CLARIFICATION ON TENDER NUMBER - IISER-PUR-1363-13

#### **ITEM DESCRIPTION- PROCUREMENT OF 25 & 30 TF HIGH PERFORMANCE CLUSTER AND 150 & 200 TB SAN STORAGE SOLUTION**

### PRE-BID CONFERENCE FOR PROCUREMENT OF 30 TF HIGH PERFORMANCE CLUSTER AND 200 TB SAN STORAGE SOLUTION

#### TECHNICAL QUERIES AND CLARIFICATION

Figure 1. Schematic of the cluster Architecture

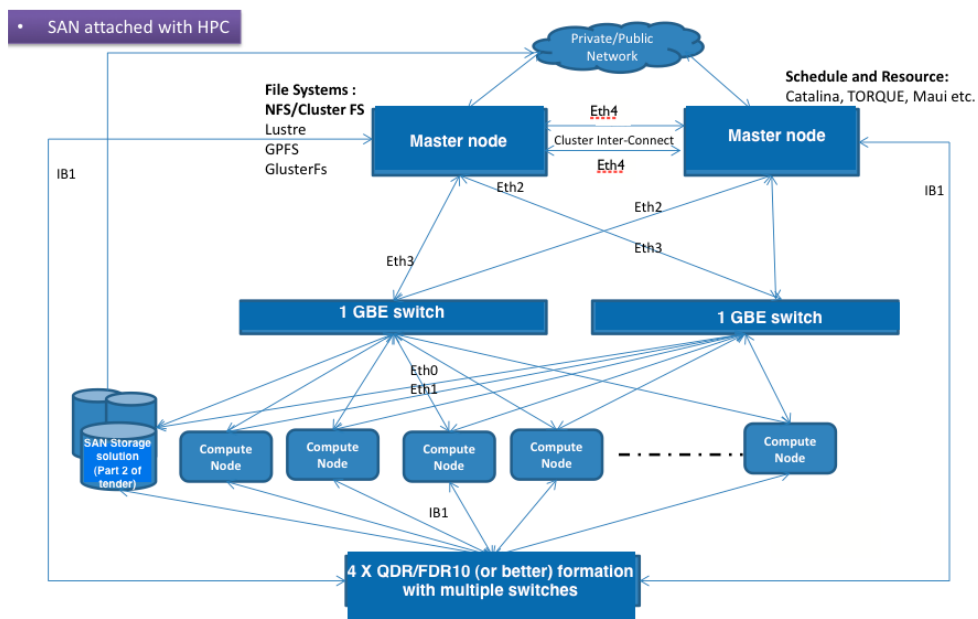
S.No	Query/Clarification Sought	Clarification / Amendment
1	<p><b>Page 26</b></p> <p>We appreciate if IISER can confirm on 10G switch configuration. From write-up we understand IISER is looking for 1G switch only and should have 4*10G ports to get connection from Management nodes. We would appreciate if IISER can help remove 10G switch here</p>	<p>This is now amended, please refer to figure 1. The configuration now shows a 1 GE switch in addition to the IB switch. Only head nodes (to connect with one another) have 10G ports and not the compute nodes.</p>
2	<p><b>Page 27</b></p> <p>0.7TFlops leads to 2U systems in configuration while typically in HPC we have 1/2 U systems available to save power &amp; space. We request IISER to change the config and allow 0.3Flops or more (using any of the 3 different processor allowed).</p>	<p>This is now amended. The peak performance requirements are now 0.35 TF or better for head and compute nodes</p>

### **GROMACS Benchmark schedule**

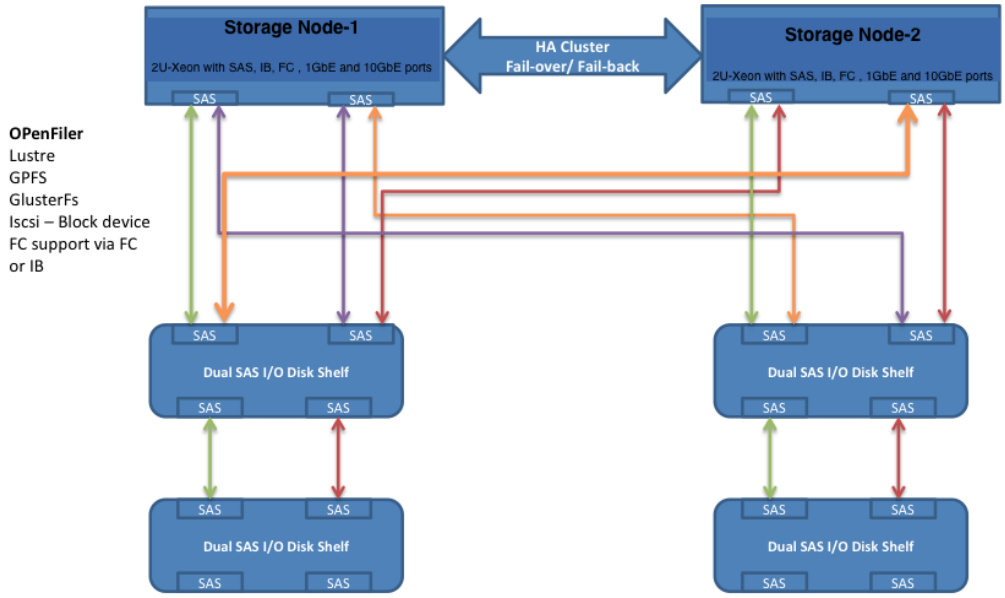
20	We support compression only on tape based archival. Can IISER please remove compression feature request?	The compression feature remains and pertains to on disc compression.
21	Can IISER please clarify if 50TB increment pricing is to be provided above 200TB capacity?	Please refer to the amendment in the tender that now specifies that bidders should quote prices for 150TB and 200TB usable capacity storage solutions. Chapter 4 Part 2 Storage
22	OEM should have atleast 8 Installation in top500.org	The clause in the tender remains unchanged. 5 entries in the top500 list consistently for the last 3 years (5 out of 6 entries would also be considered)
23	Submitting benchmark on multiple option i.e. 2TF, 5TF,10TF plus also on 20TF and 30TF will be very time consuming activity considering activity listed in RFP and difficulty in getting allocation of the 30TF benchmark System. Request IISER to ask benchmrk on 2TF and 5TF as mandatory and balance as option. Requesting IISER to clarify names of all the 7 test required under HPC Challenge Benchmark.	This clause is amended to The bidder should carry out below listed benchmark programs on 5TF and 10TF configurations of the offered solution and submit the results achieved (with TFLOP count where applicable) in an output file, in the technical bid. 1. HPCB Benchmark: ( <a href="http://icl.cs.utk.edu/hpcc/">http://icl.cs.utk.edu/hpcc/</a> ) do only HPL 2. BioPerf code. ( <a href="http://www.bioperf.org/">http://www.bioperf.org/</a> ) 3. Cbench: stress testing and analyzing cluster ( <a href="http://sourceforge.net/apps/trac/cbench">http://sourceforge.net/apps/trac/cbench</a> ). 4. GROMACS (see GROMACS benchmark schedule below)  See Chapter 4, Part 1: section on Benchmarks
